Bridge Factors Factual Report Attachment 73 – FHWA Assessment of Bridge Design and Performance

**Florida International University Pedestrian Bridge Collapse Investigation:
Assessment of Bridge Design and Performance**

National Transportation Safety Board
NTSB Accident ID: HWY18MH009

September 12, 2019

Figure 14. Illustration showing the steel reinforcing bars passing from the deck into the base of truss member 11.

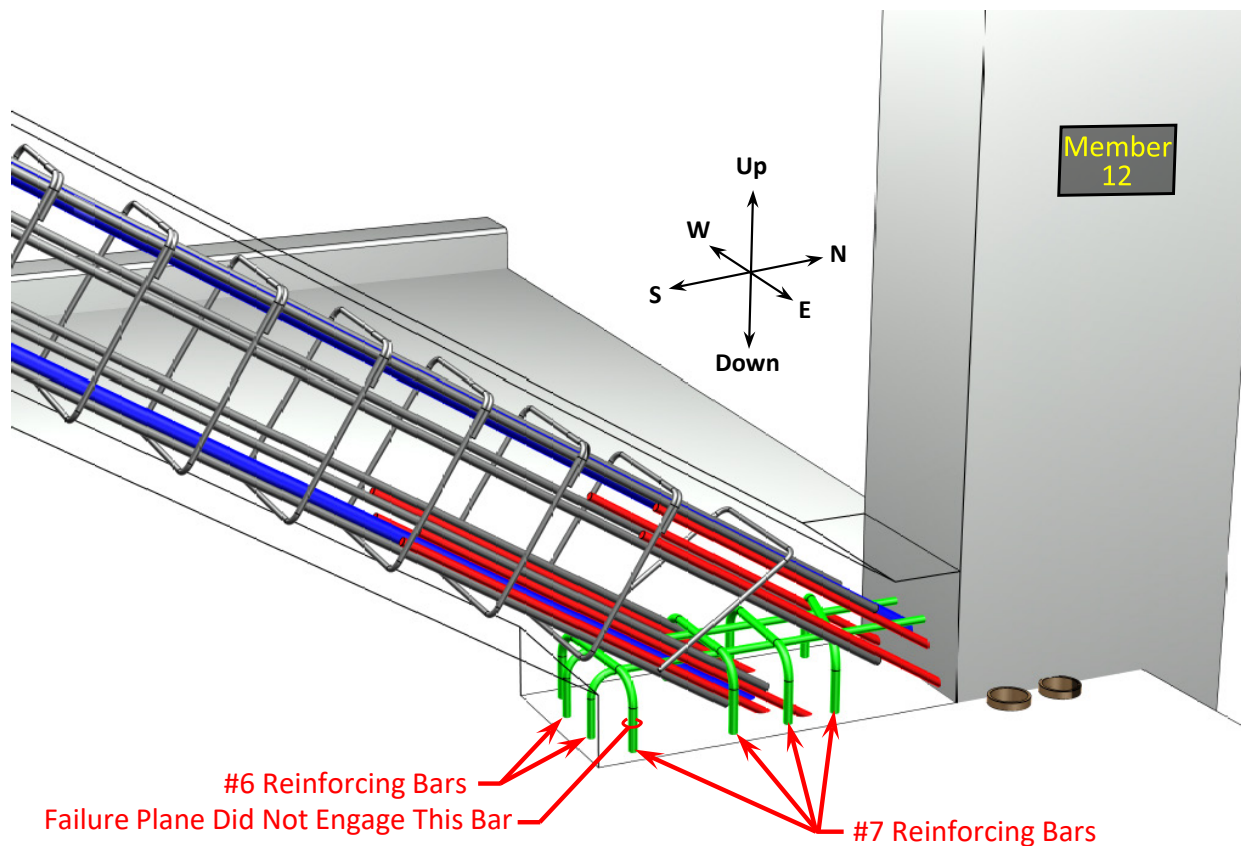
The FIGG Plans called for a detailing scheme wherein the southernmost two reinforcing bars were not anchored on both sides of the critical horizontal shear plane at the base of member 11. This detailing scheme resulted in less reinforcing steel than expected participating in resisting the critical interface shear demand.

The second deviation from the FIGG Plans pertains to the interface shear reinforcement crossing from the deck into the base of member 11, shown as the green bars in Figure 14. These

Figure 56. Illustration showing a rendering of the construction plans for the member 11 and 12 nodal region along the truss line of the bridge.

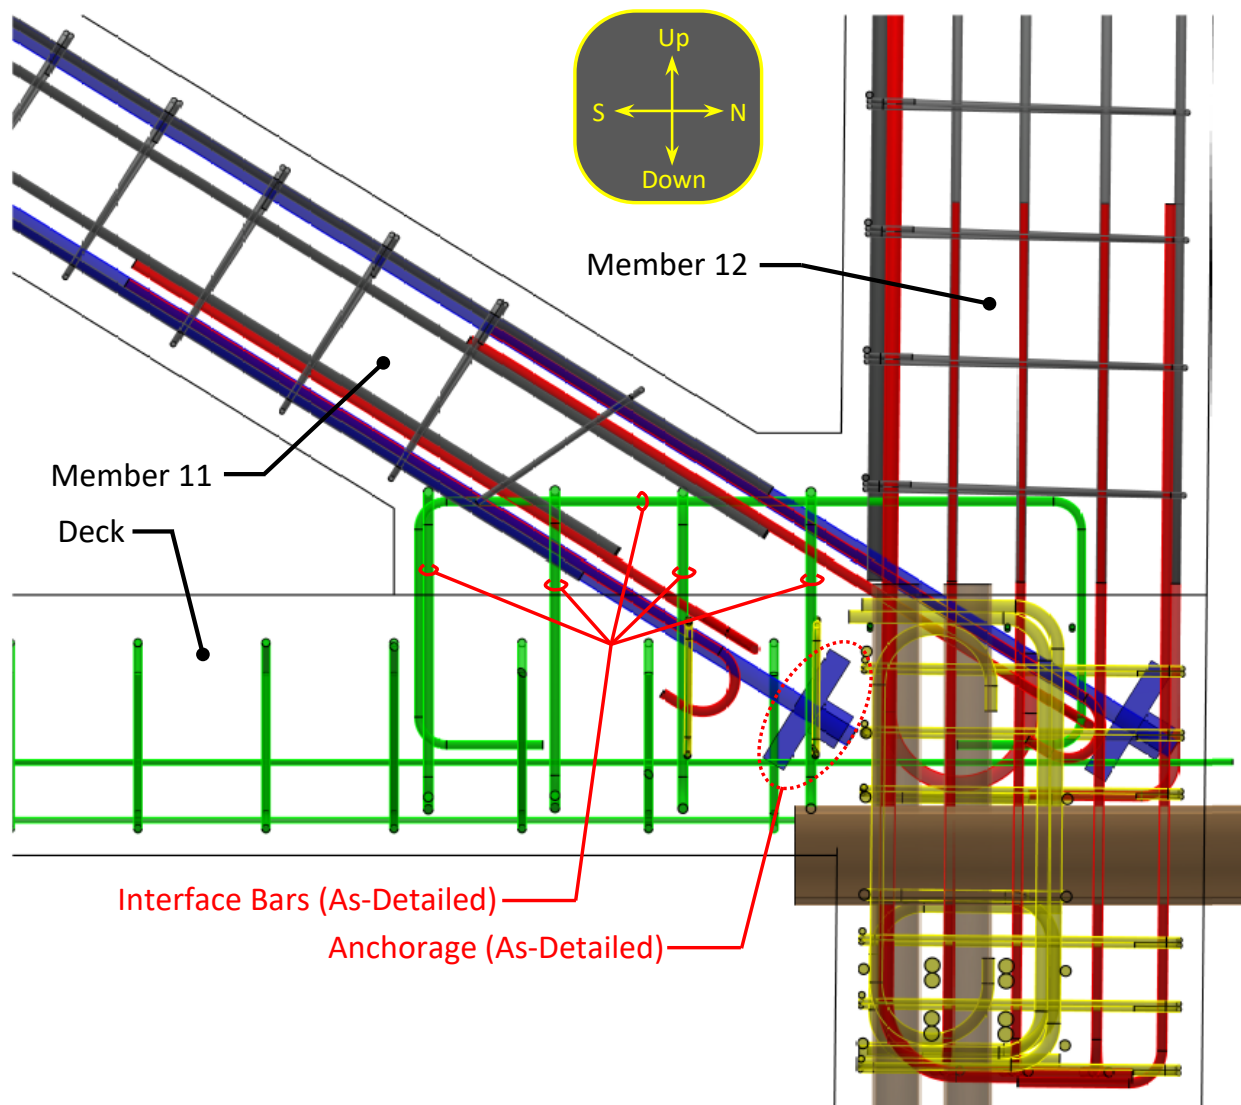
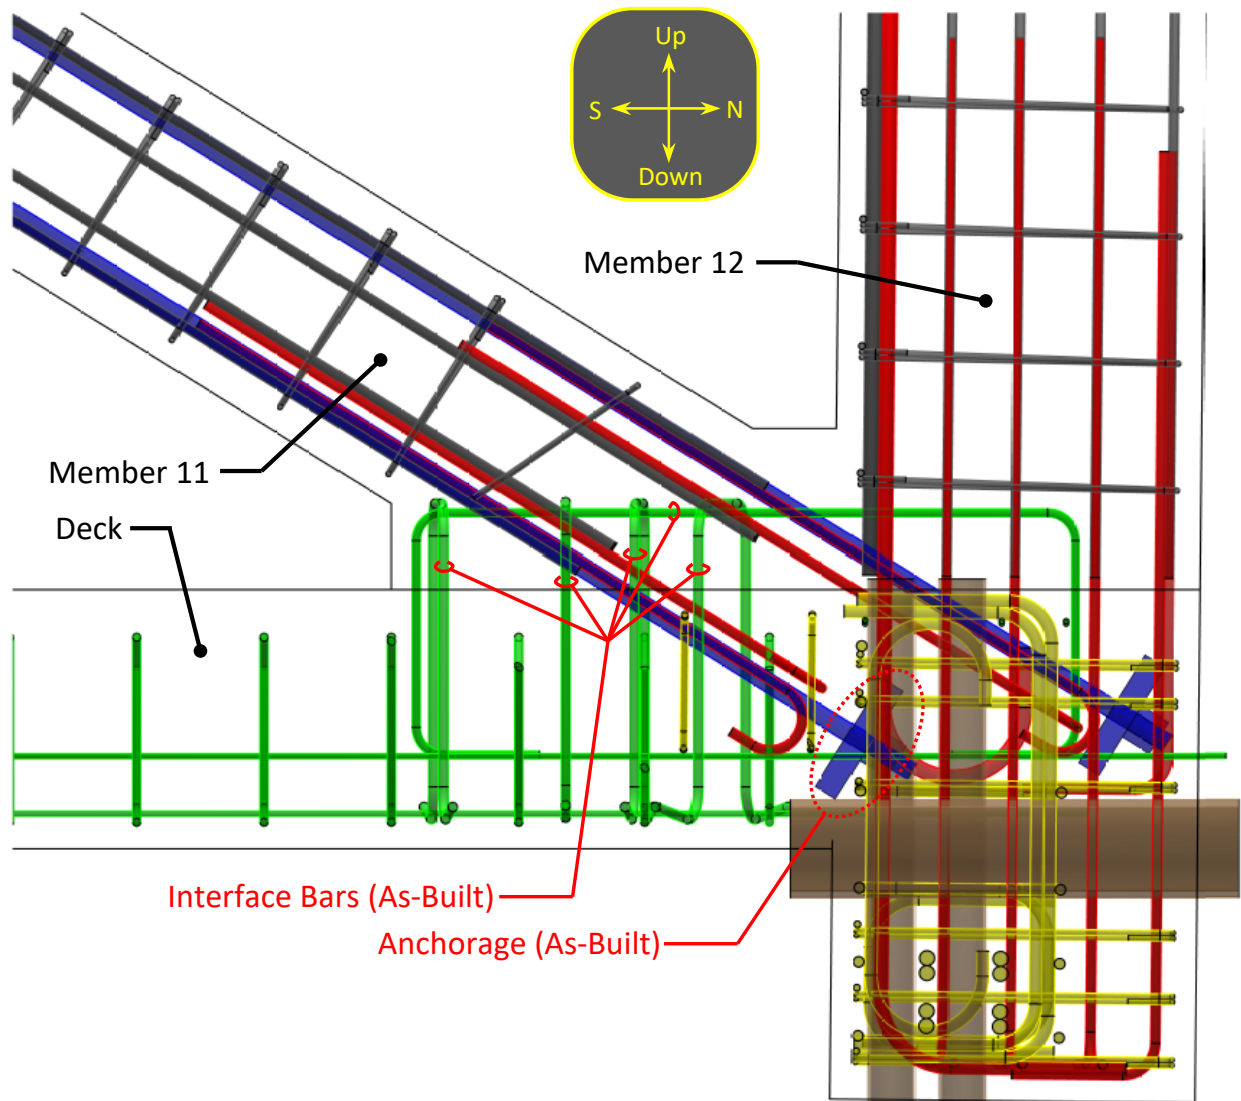
Two specific deviations from the FIGG Plans were identified through this reinforcement reconciliation process. Both deviations can be observed through comparison of the renderings in Figure 56 and Figure 57. Figure 56 was created based on the FIGG Plans, and Figure 57 is a modified version wherein the identified differences in reinforcement positions have been implemented. Note that all the 3-dimensional renderings in this report are based on the modified model presented in Figure 57 since the reinforcement positions it shows reflect the structure at the time of collapse.

The first deviation from the FIGG Plans pertains to the lower anchorage for post-tensioning rod 11S. Figure 55, Figure 48, and Figure 49 were instrumental in reconciling the as-built location. The reconciliation found that the anchor plate for rod 11S was embedded slightly deeper into the bridge deck than was shown on the FIGG Plans. The line of action of the rod was maintained (i.e., the position of the rod within member 11 and the angle relative to the remainder of the structure was not changed), but the anchor plate and nut were positioned approximately 7 inches farther along the original line of action (i.e., northward and downward) relative to the FIGG Plans.

These two deviations from the FIGG Plans also necessitate the minor movements of a few other reinforcing bars which would conflict with the new locations of the anchor plate and the interface shear reinforcement. The conflicting bars were moved as little as possible while ensuring that their as-built locations best aligned with the available evidence. These conflicting bars can be identified by comparing the images in Figure 56 and Figure 57.

Figure 62. Force from truss member 11 on the nodal region shear interface surface.

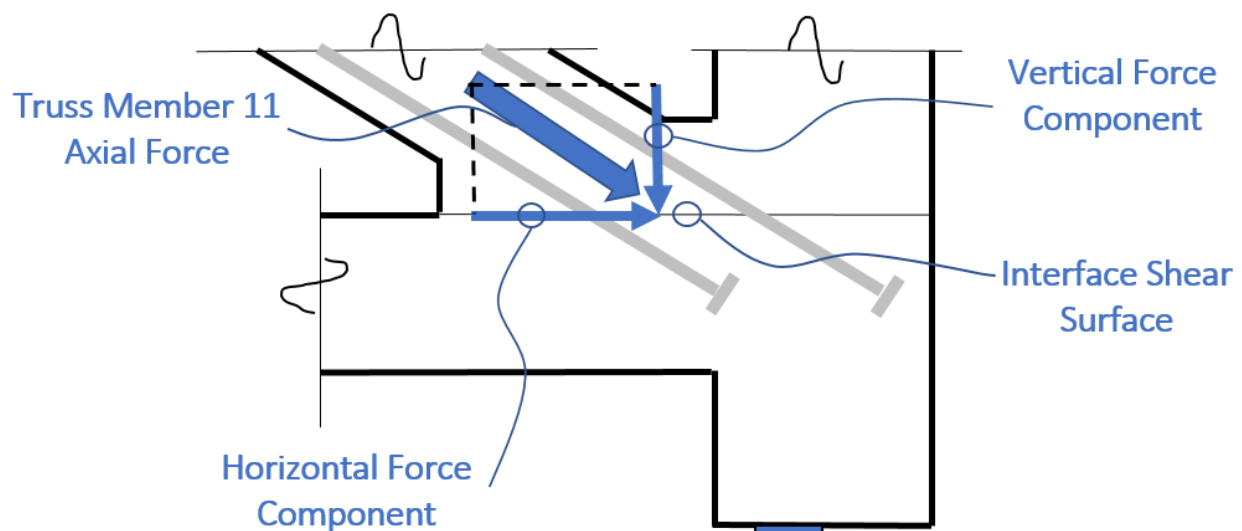
Each analytical model generated multiple force effects for every structural component included. For the design of the truss member connections, the truss member axial forces were extracted from these analyses and used in the design of each truss member connection. The axial force in the truss member was subsequently resolved into vertical and horizontal components. This resolution of forces is illustrated in figure 62 for the 11-12 nodal region, where the large arrow represents the axial force in Member 11 from the analytical model, and the two smaller arrows represent this axial force resolved into two orthogonal components acting on the interface shear surface. The vertical component is the compressive or clamping force that contributes to interface shear resistance. The horizontal component is the shearing force on the interface shear surface or the interface shear demand. Axial forces in the truss members due to dead load (self-weight) of the structural components and non-structural attachments (DC), pedestrian live loading (PL), forces induced in the structure from post-tensioning (PT), and forces induced in the structure due to temperature (TU) were extracted from the analytical models and used in the FIGG Design of the force transfer across the shear interface surface in the nodal regions.

Figure 63. Nodal zone interface shear demand results generated for the FIGG Design.

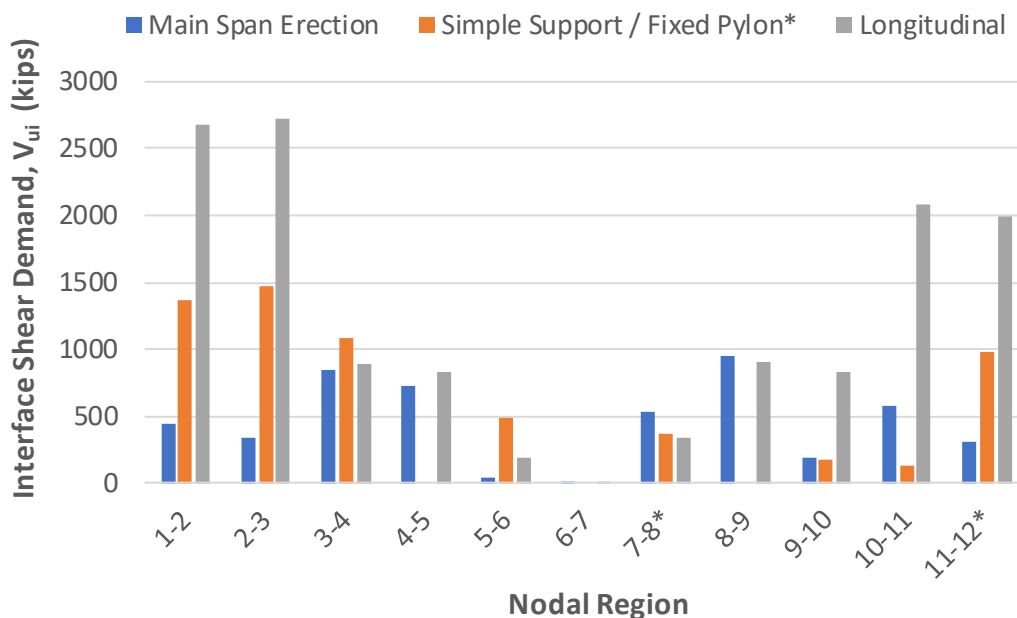
Figure 63 shows the interface (horizontal) shear demand results for each main span truss nodal region generated from the four models used in the FIGG Design. With regard to the results from the Simple Support Model and Fixed Pylon Model, the FIGG Design only included the forces identified by the designer as most critical between these two models. Therefore, the results shown in figure 63 only reflect the identified maximums between these two analytical models. The Simple Support Model generated the governing interface shear force effects for every nodal region except for nodal regions 7-8 and 11-12. The governing interface shear force effects for nodal regions 7-8 and 11-12 were generated from the Fixed Pylon Model. The FIGG

Design did not include the results from the Main Span Erection Model or the Longitudinal Model when they were comparing interface shear demands in order to determine the maximum force effects. The interface shear forces shown in figure 63 are generated from the load combination and load factors prescribed in the AASHTO LRFD Strength I limit state. This limit state was used for the interface shear design of all truss cold joints in the nodal regions. The two numbers shown on the horizontal axis of the figure 63 chart identify each nodal region by the two truss member identification numbers (refer to figure 4) that connect into that region.

The chart in figure 63 shows that the interface shear demand generated for each construction stage can vary significantly. Both the magnitude of the interface shear demand and concurrent permanent net compression force, P_c , need to be considered for each construction stage in determining the governing load case for each nodal region. Therefore, the largest interface

Figure 63 also shows that the forces generated from the Longitudinal Model (for the completed bridge structure) generated the largest forces for the nodal regions at the north and south ends of the main span. *It should be noted that the FIGG Design exclusively used the results from the Simple Support / Fixed Pylon modeling combination for the design of every main span nodal region.*

Figure 65. Nodal zone horizontal shear modeling results comparison between FIGG Design and FHWA Check.

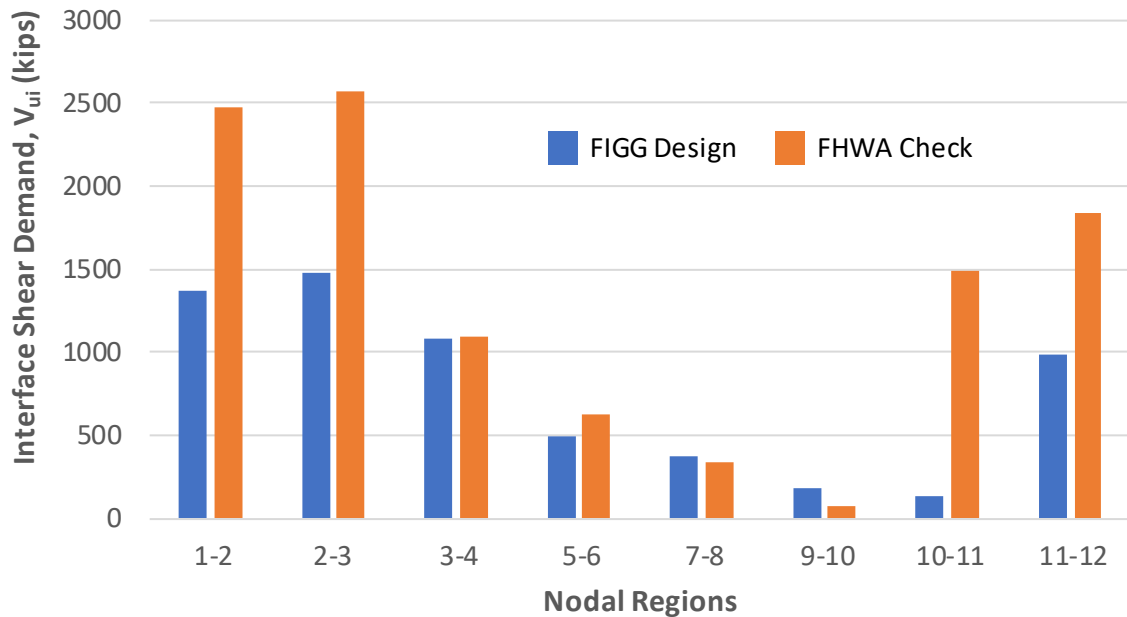
Figure 65 shows a comparison of the interface shear demands generated by the analytical model used by the FIGG Design and those generated from the FHWA Check analysis. The AASHTO Strength I Limit Strength was used to generate the interface shear demands for both the FIGG Design and FHWA Check. The results for the FIGG Design came from the Simple Support and Fixed Pylon Models. For clarity, the results are only shown for the nodal zones that were included in the FIGG Design. Nodal regions 4-5, 6-7 and 8-9 were not included in the FIGG Design. Truss members 2 and 11 carried the highest force levels in the main span and failure of nodal region 11-12 initiated the collapse.

- Nodal Region 1-2 – The force effect selected by the FIGG Design of this nodal region underestimated the maximum force effect by approximately 1,100 kips (49%)
- Nodal Region 2-3 – The force effect selected by the FIGG Design of this nodal region underestimated the maximum force effect by approximately 1,100 kips (43%).
- Nodal Region 10-11 – The force effect selected by the FIGG Design of this nodal region underestimated the maximum force effect by approximately 1,360 kips (91%).
- Nodal Region 11-12 – The force effect selected by the FIGG Design of this nodal region underestimated the maximum force effect by approximately 850 kips (46%).

Figure 66. Interface surface zones 1, 2, and 3.

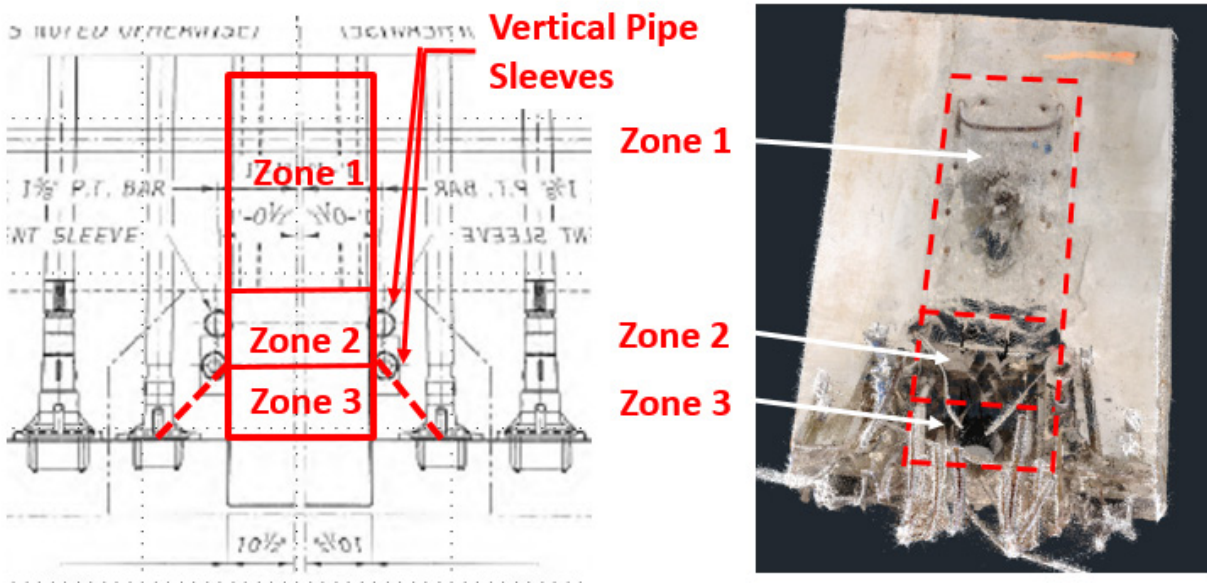
Figure 66 shows a plan view of the nodal region 11-12 footprint from the FIGG Plans (plan view shown on left) as well as from a post-collapse laser scan of the same region (image shown on

A unique detail that occurs at nodal region 11-12 is the presence of two vertical pipe sleeves that flank both faces of the 11-12 nodal region (4 pipes total). These vertical pipes penetrate the full depth of the bridge deck and essentially isolate or “wall-off” the area bounded by these pipes. Consequently, the area identified as Zone 2 in Figure 66 is also isolated from the deck and therefore should not be used in the interface shear capacity calculation for the 11-12 nodal region.

The interface shear designs included in the FIGG Design only used the interface shear transfer areas under truss member 2 for the 1-2 nodal region design and interface shear transfer area under truss member 11 in the 11-12 nodal zone for the nodal region designs. Although the designer’s intent cannot be deduced, the FHWA Check determined that the FIGG Design correctly chose to exclude Zone 2 and Zone 3 in determining the area engaged in interface shear transfer.

Figure 67. Interface shear capacity breakdown.

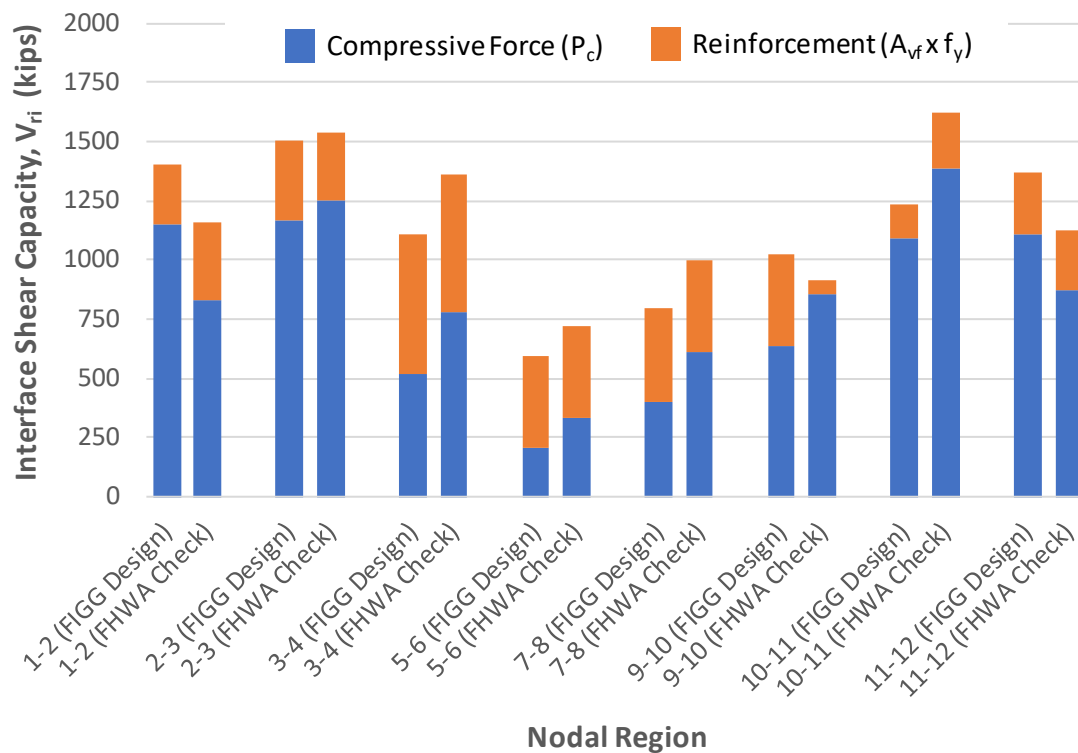
The capacities shown in the bar graph in Figure 67 are broken down into the two capacity-supplying mechanisms. These are identified as capacity from compressive force (P_c) and capacity from reinforcing steel ($A_{vf} \times f_y$). The interface shear capacity values calculated in the FIGG Design are shown. The FHWA calculated capacity values based on the FIGG Plans with appropriate interpretation of the AASHTO LRFD are also shown.

Figure 68. Demand to capacity ratios for main span nodal regions.

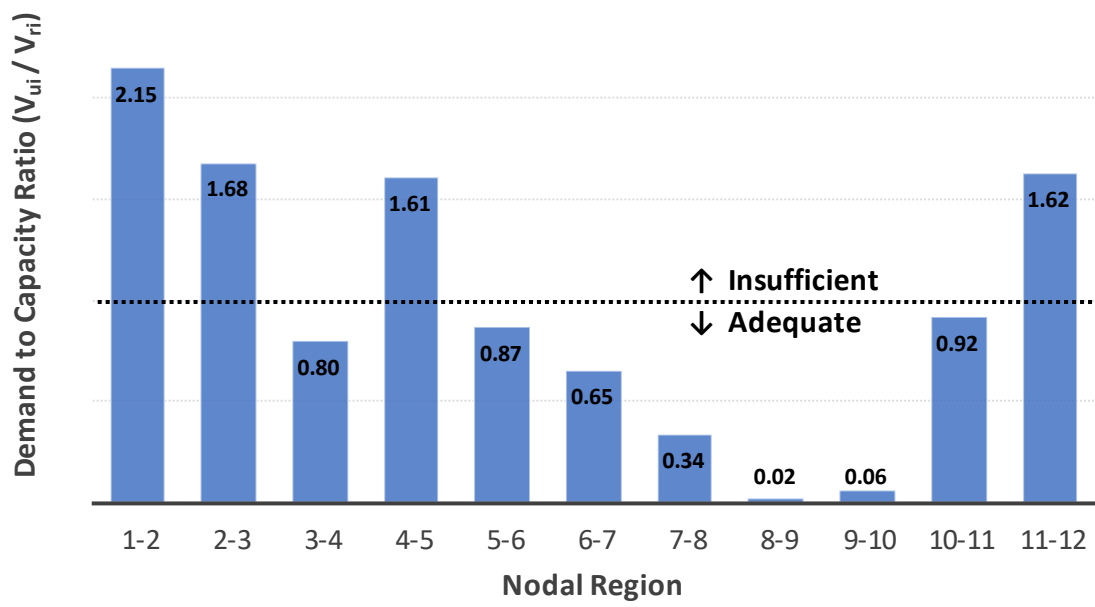
Figure 68 below displays ratios in which the maximum interface shear demands (forces) acting upon a nodal region is divided by the capacity provided by the nodal region. This produces a ratio commonly referred to as the demand to capacity ratio (D/C). A demand to capacity ratio less than or equal to 1.0 represents an assessment that the capacity provided by the nodal region can adequately carry the applied loading (as prescribed by the design requirements). The lower the value the more conservative the design. A demand to capacity value above 1.0 represents an assessment that the capacity provided by the nodal region is not sufficient to carry the applied loading (as prescribed by the design requirements). The higher the value, the more under-designed the connection. Figure 68 includes D/C ratios for every nodal region in the main span at the time of collapse.

The maximum demands used to compute the D/C ratios in figure 68 were based on the FHWA Check load case for Stage 2 (from Table 2). The capacity was calculated using the interface shear transfer area, A_{cv} , and the reinforcing steel area crossing the interface plane, A_{vf} , as shown on the FIGG Plans (from Table 3). Cohesion was not included in these capacity calculations. In addition, the compressive force, P_c , acting on each interface surface is the concurrent load generated by the FHWA Check for Stage 2. The compressive force used for nodal regions 1-2 and 11-12 includes the temporary post-tensioning in truss members 2 and 11.
